Catalog Processors	Texas Instruments, Inc.		
	Catalog Processors Business Unit		
	12500 TI Blvd		
	Dallas, TX 75243		
	Final		
	AM571x Industrial Development Kit (IDK) EVM - TMDXIDK571B		
	Processor Power		
Doc #	Document Number	Modified By	Rev
C48000		John Johnson	1.0
Date	Sheet		2 of 2

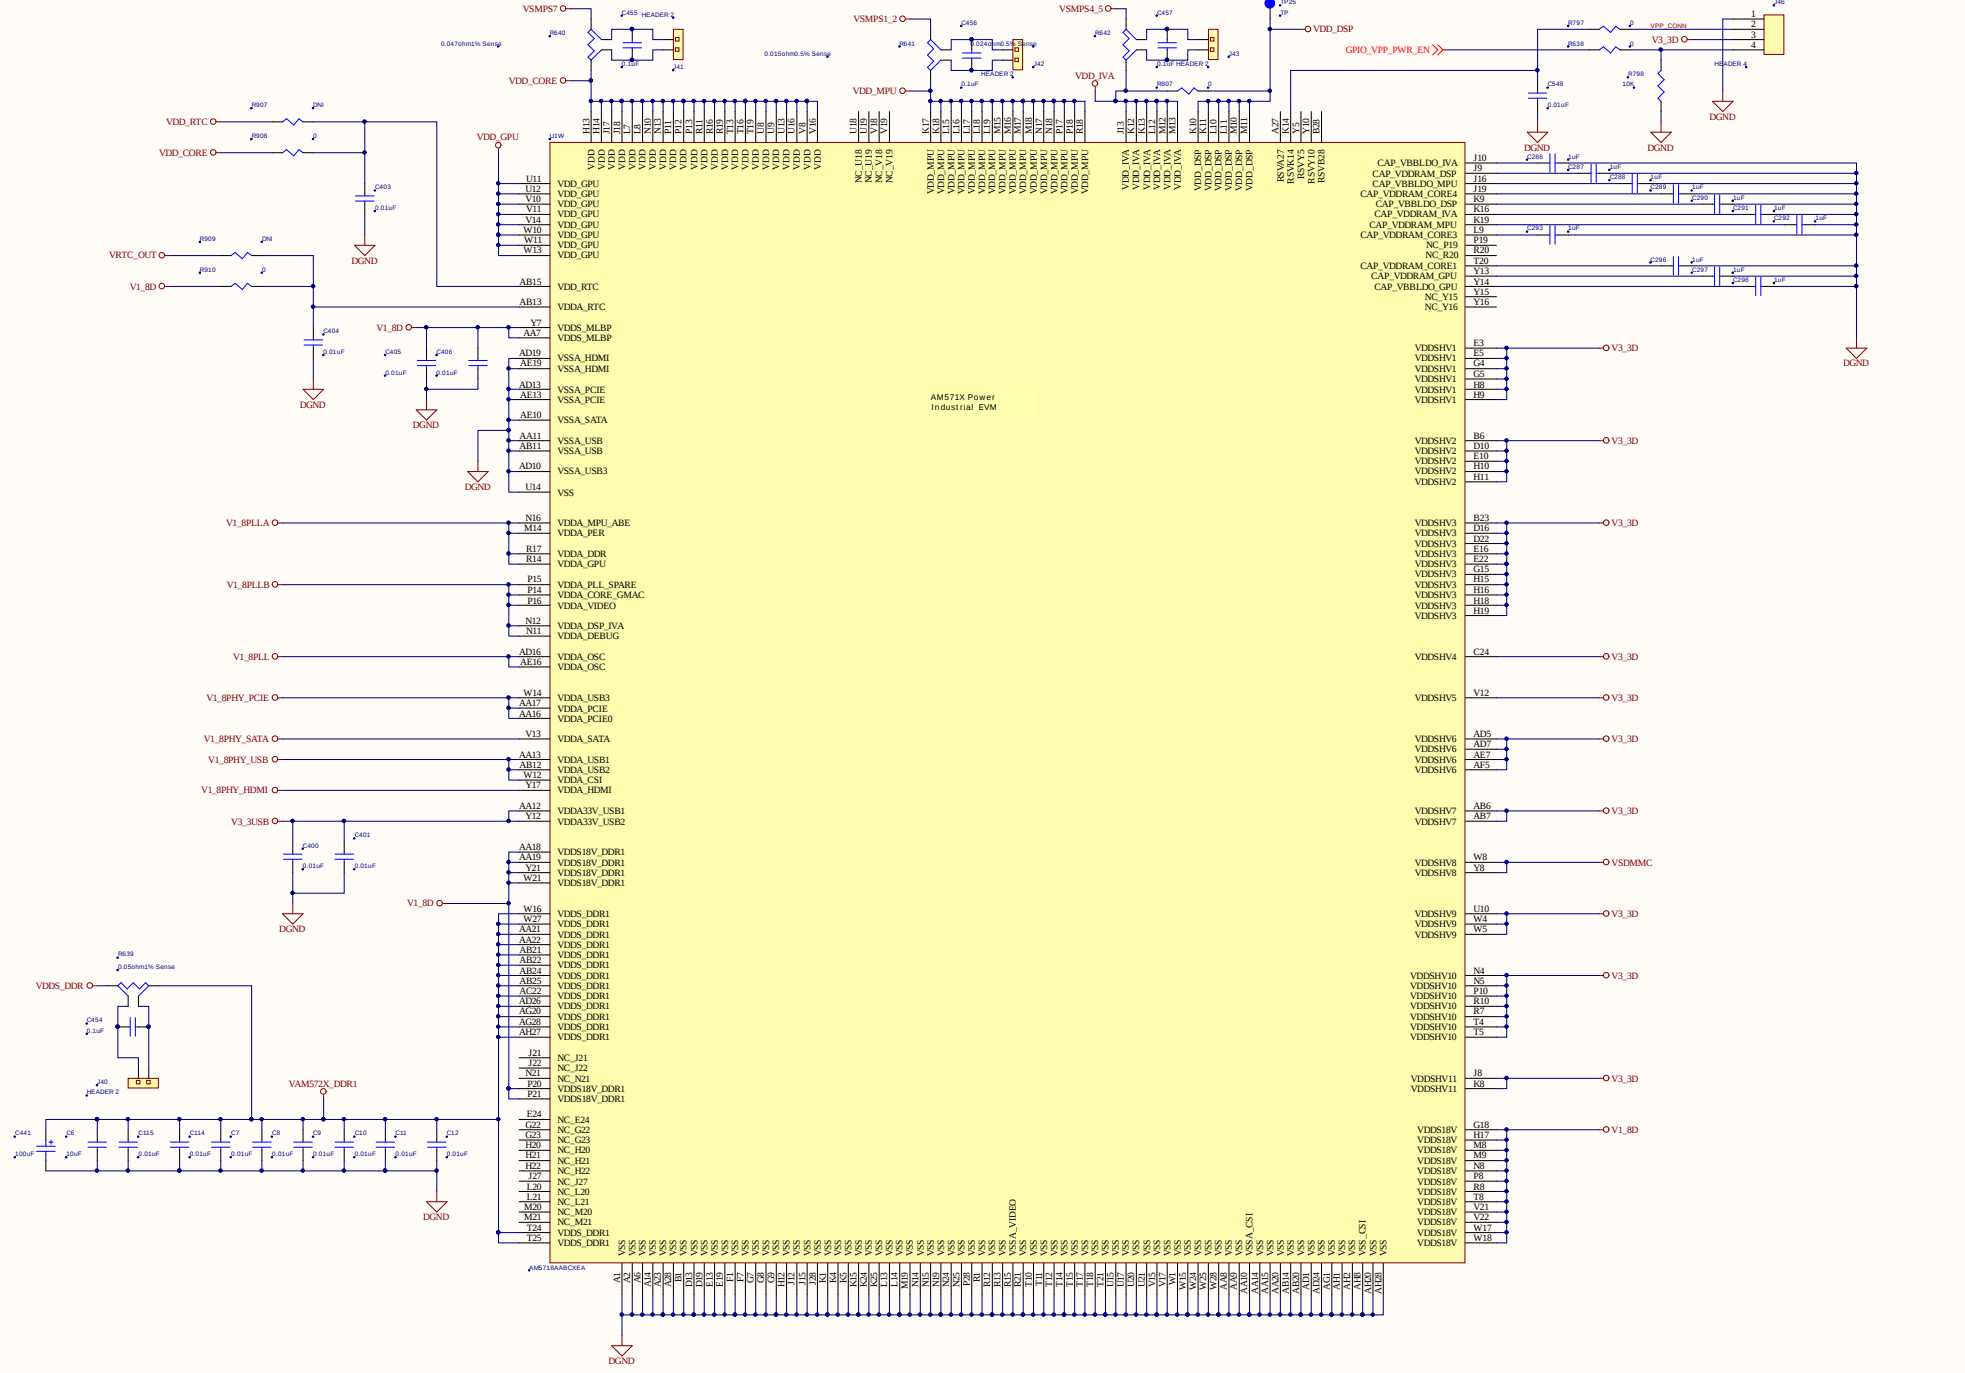
It has been later determined that the clamp circuit on VSDMMC is not sufficient and the PMIC was enhanced to better control shut-down sequencing. Therefore, the VSDMMC clamp is no longer required. The power-down sequence defined in the Data Manual must be met.
